RE: Response to Review Comments
Mt. Kineo Builders, LLC
47 Sharp Hill Road, Montville, CT

H+H Engineering Associates, LLC (H+H) is in receipt of the following review comments regarding the Subdivision application (Application 25 Sub 7 & 25 SP 1) for the project located at 47 Sharp Hill Road:

November 17, 2025
2025-0197

Routing Diagram for 2025-0197 - PROP WSHD - REV2
 Prepared by HH Engineering Assoc, Printed 11/17/2025
 HydroCAD® 10.20-7a s/n 12772 © 2025 HydroCAD Software Solutions LLC

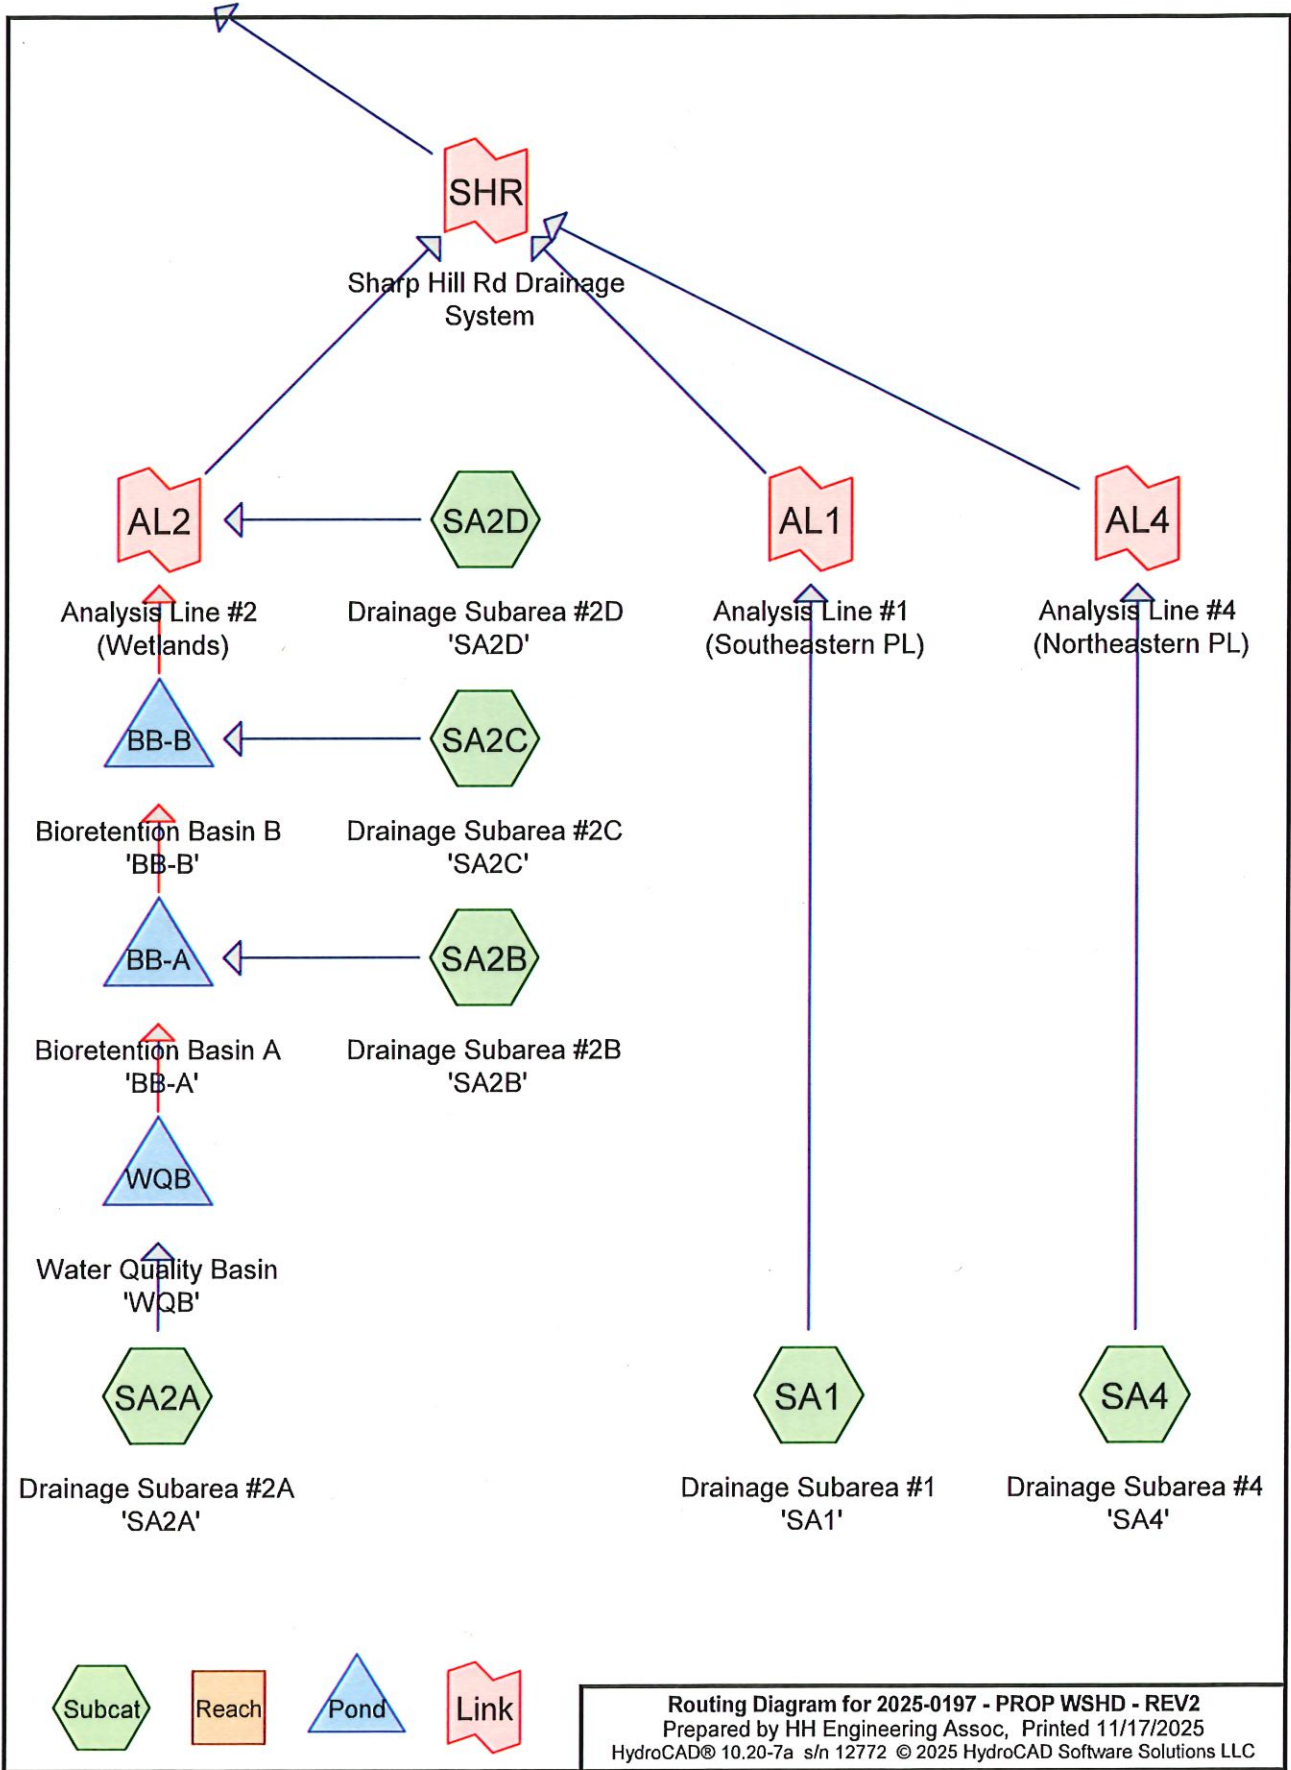
ADDITIONAL COMMENT: The Applicants Engineer noted the installation of the new catch basin in Sharp Hill Road will help to collect and convey stormwater to reduce the potential for ponding/icing downgradient of the development. However, the previous icing issues in Sharp Hill Road was primarily from overland flow from the properties surrounding #19 Sharp Hill Road and potentially from the subject property (excerpt of the Town GIS mapping attached). The Town previously installed storm drainage to capture flow and mitigate the icing issues. Please provide commentary on the location and flow from the

stormwater discharge for this proposed development and potential impacts to the downstream properties, existing stormwater system and Sharp Hill Road. In particular changes in peak flow and runoff volume for the combined Analysis Lines 1, 2, and 4.

The subject site is upgradient of 19 Sharp Hill Road. Flow within the vicinity of Sharp Hill Road, including the subject site and the off-site property identified, generally travels from west to east toward Maple Avenue before ultimately discharging in Rockland Pond.

Based on available mapping, a portion of the subject site (Drainage Areas 1, 2, and 4 as shown on the Pre- and Post-Development Drainage Area Maps) drains onto downgradient abutting properties to the east that convey flow to the Sharp Hill Road drainage system, which eventually discharges to Maple Avenue and Rockland Pond. Those three drainage areas correspond to Analysis Lines 1, 2, and 4.

When evaluating the combined pre- and post-development peak rates of runoff and volumes of runoff for these analysis lines, the HydroCAD modeling results indicate a reduction of peak rate of runoff and total volume of runoff to the downgradient properties. A summary of the combined pre- and post-development results is provided below:

Based on the above modeling results, the proposed improvements will reduce peak flow rates and total runoff volumes contributing to the downstream properties and the Sharp Hill Road drainage system.
